SRI NAM ECR-003

ENGINEERING CHANGE REQUEST (ECR)

DRAWING TITLE Box Beam 1, 2, 3

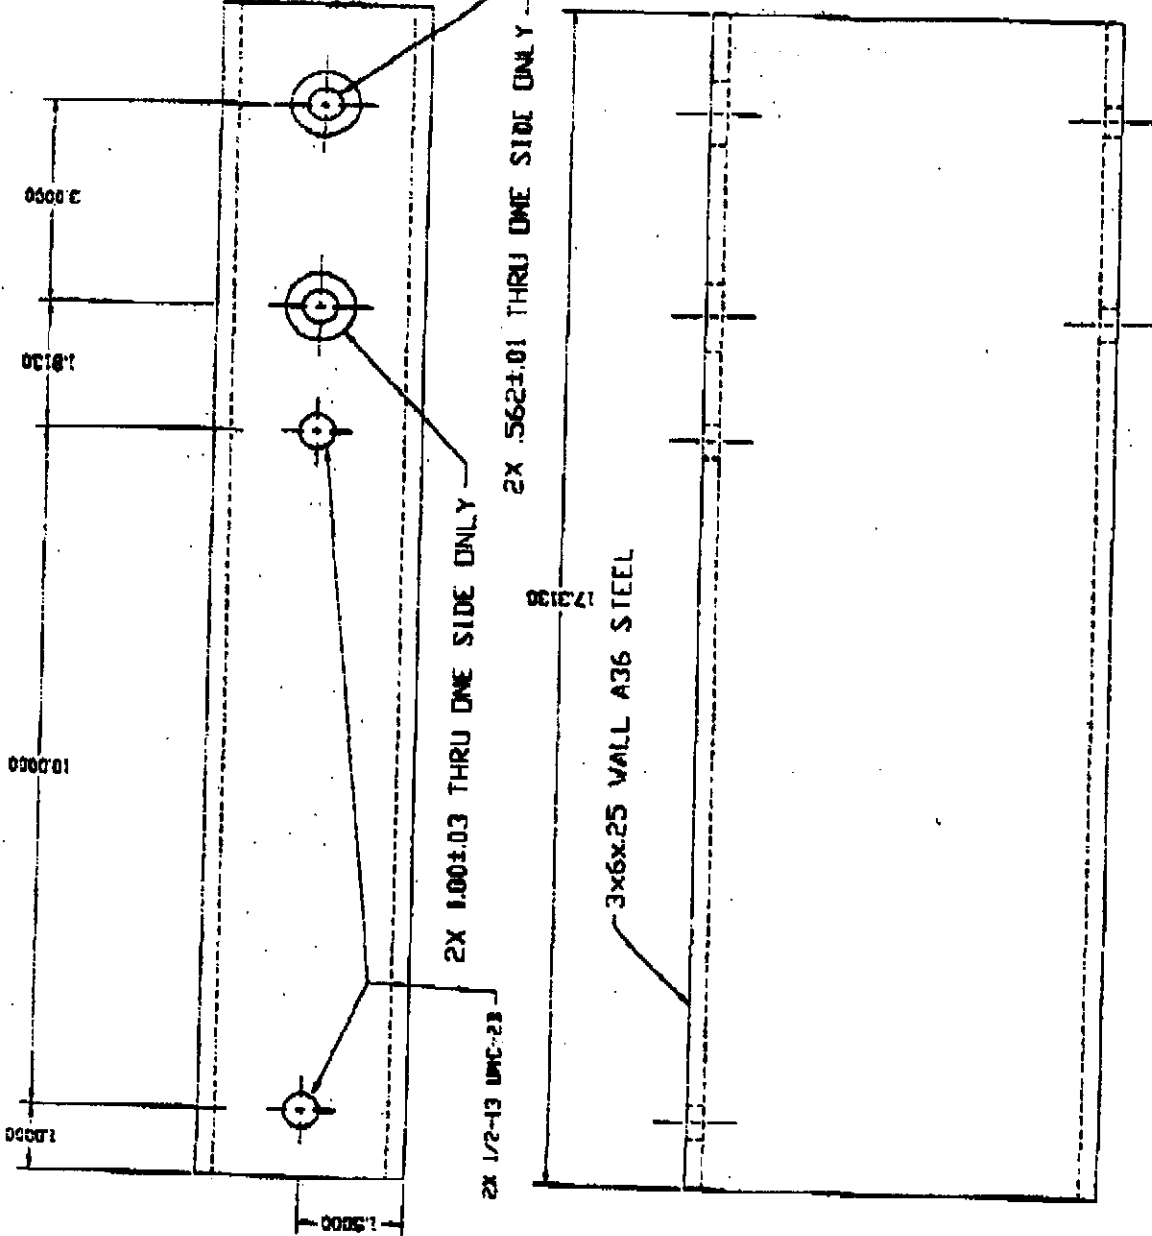
Utilize Box Beams to Support Rail System

Decoupling of Support Tube & Crossbeams.
